# Manual 15

## Biennial Review Changes

Action Required	Deadline	Who May Be Affected
Review Manual 15 updates	08/07/2024	Market Sellers

~~Exhibit 26: Name to be determined~~

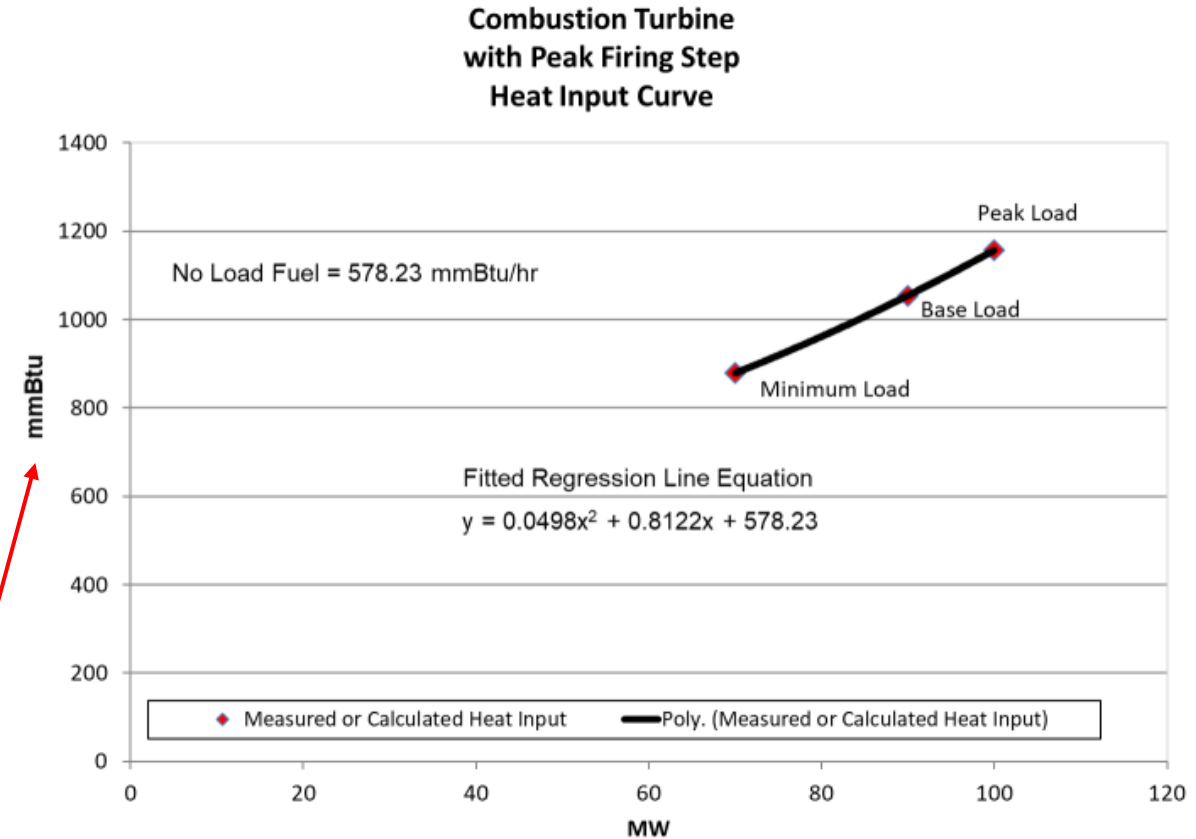
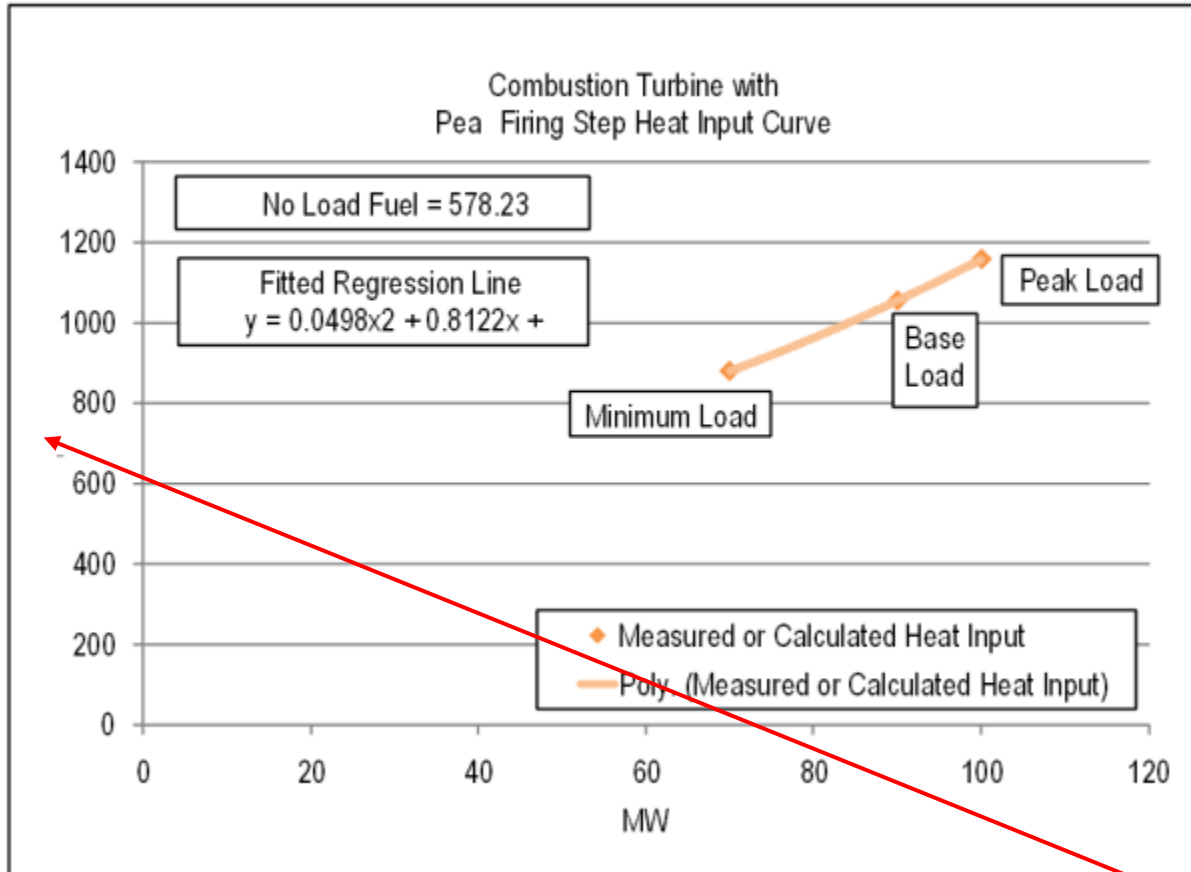
Replace any graphs with missing Y-axis labels
